18 March 2024

Joint Meeting of the RID Committee of Experts and the
Working Party on the Transport of Dangerous Goods

Publication of the 3rd edition of International Railway Solution (IRS) 50592

Transmitted by the International Union of Railways (UIC)

Fig. 20 - Bottom fittings

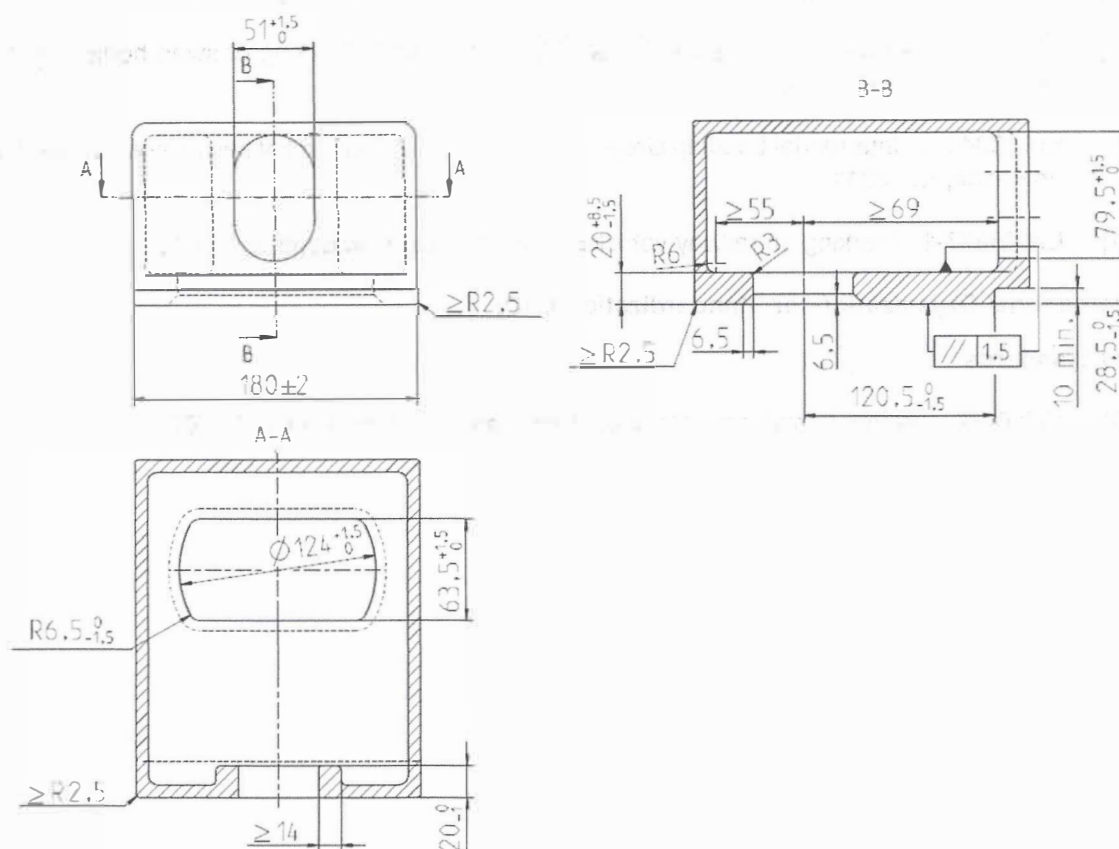
The drawings in Appendix D of the 2nd edition are obsolete. They have been replaced by a new drawing.
8. For Appendix E, see figure in annex 4 (text highlighted in yellow).

Note: The base plate of the bottom fittings must be the lowest point on the ILU in all cases.

Fig. 23 - Marking for ILUs equal to or longer than 30 feet which must be transported on pocket wagons with intermediate supporting surfaces (see point 8.7.2 - page 30)

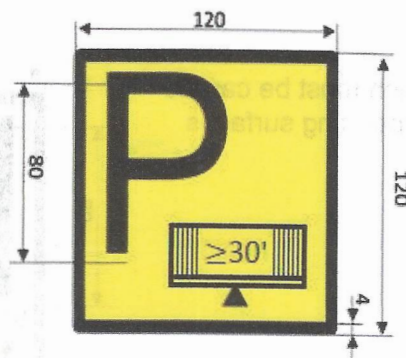
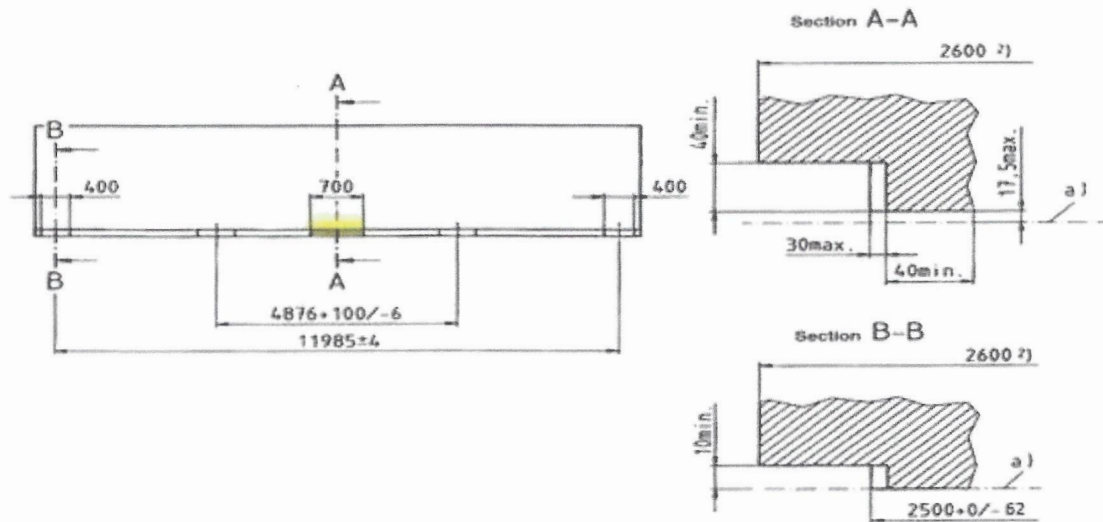
Marking (Fig. 23) modified in accordance with the modifications introduced in point 6.2.1.1.
9. For Appendix G, see annex 5 (text highlighted in yellow).

Fig. 36 - Marking for swap bodies with tarpaulins for securing the cargo

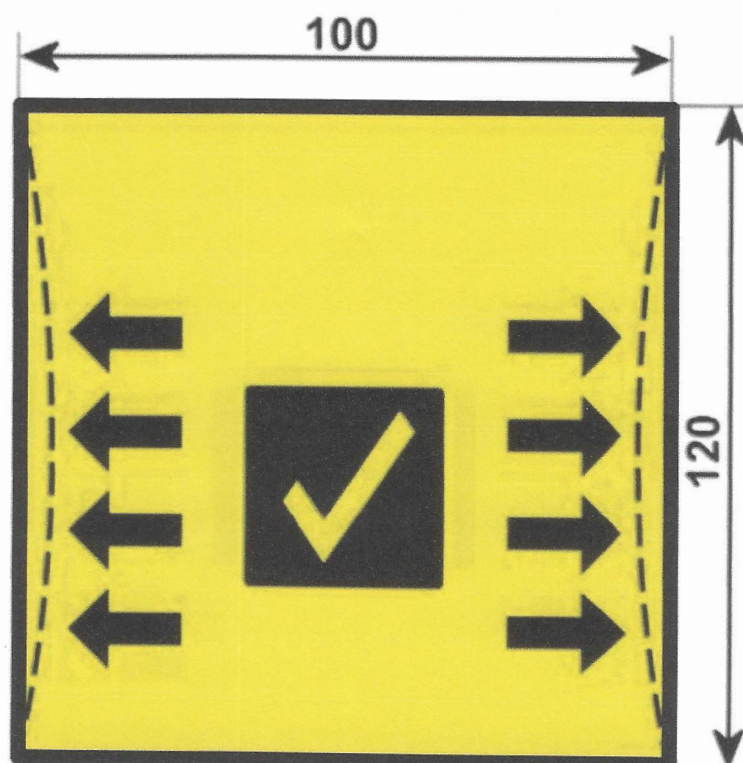
Editorial modifications to the related marking (fig. 36).
